ADDENDUM #02

Project Name: DART OPERATIONS & MAINTENANCE PHASE 1 – **BID PACKAGE 13 RE-BID**

DCI Project #: 23-005

Date: 12/02/2024

① 2030- Battery Bench Plan
3/4" = 1'-0"

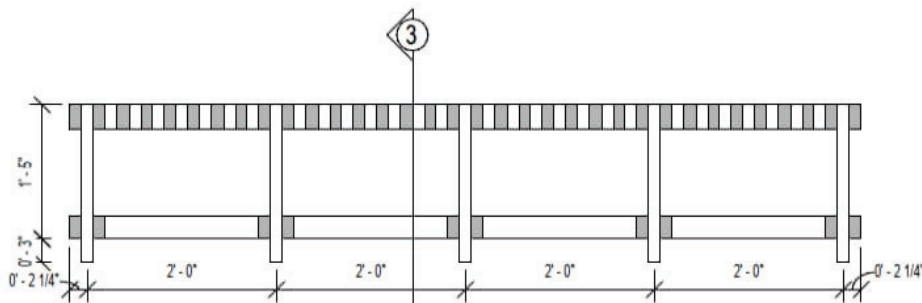
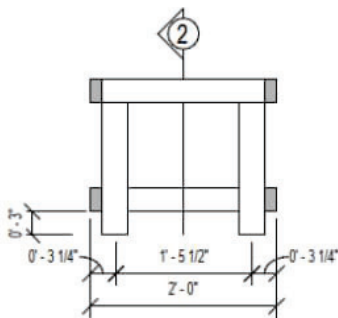
1. Q: Please confirm the quantity of in-ground lifts (item 5651).
 - A: There are (6) in-ground lifts (item 5651) as labeled on Q1.01 and Q1.02.
2. Q: Battery Bench (item 2030) does not call out a length in the prints/specs, it just says “as shown.” Can a length be provided?

- A: The length of each battery bench is 8’- 4 ½”, see supplemental cut sheet provided with this addendum.
3. Q: Relief cuts or concrete joints cannot be within 45” x 45” of each post for lift equipment. Please confirm this is understood.
